Introduction/Summary

TO: Urban Design Commission
FROM: Lisie Kitchel, Bay Creek Neighborhood
DATE: June 26, 2020
SUBJECT: 113 Lakeside St. (VFW site) Proposed Development

Re: 133 E. Lakeside St. Item # 60406

IMAGE 2/3: NON COMPLIANT ADA SIDEWALK AT TRACKS

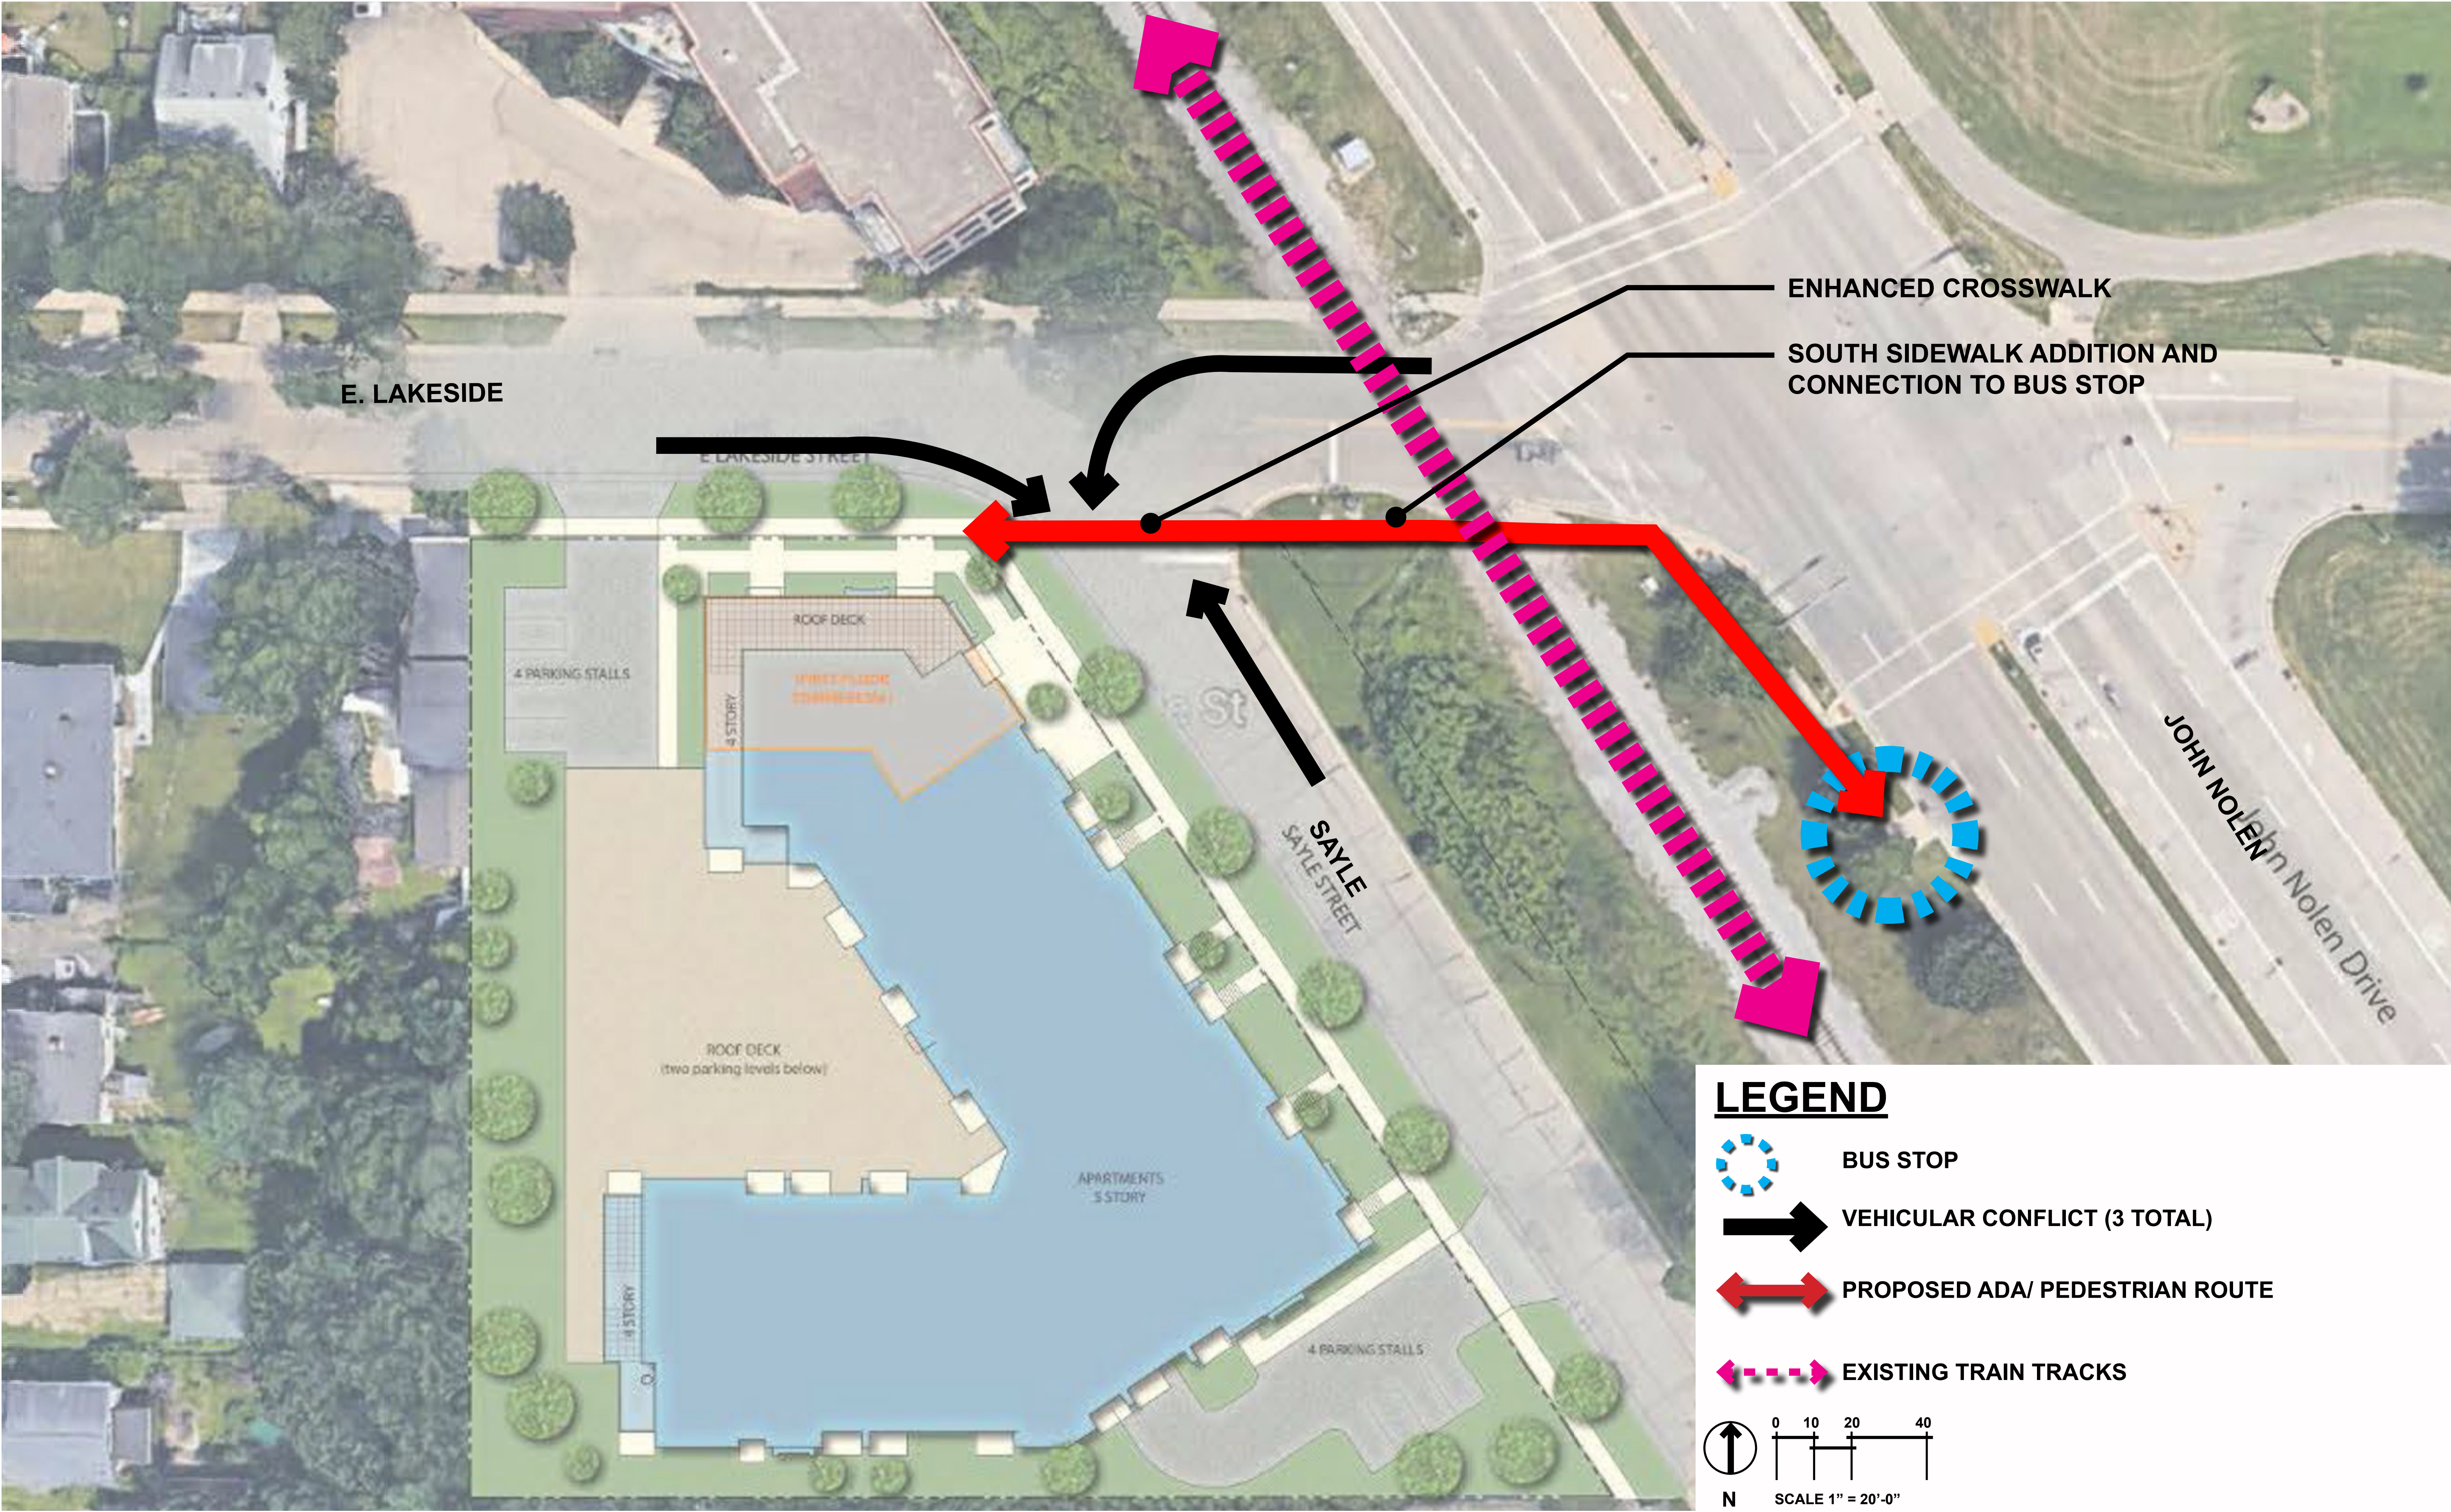
- 1) Traffic congestion and pedestrian crossing at Lakeside/Sayle intersection – Plans to modify this challenging intersection are needed to manage turns into and out of Sayle, pedestrians crossing to the bus stop, and the lack of sidewalk from Sayle east to the bus stop.
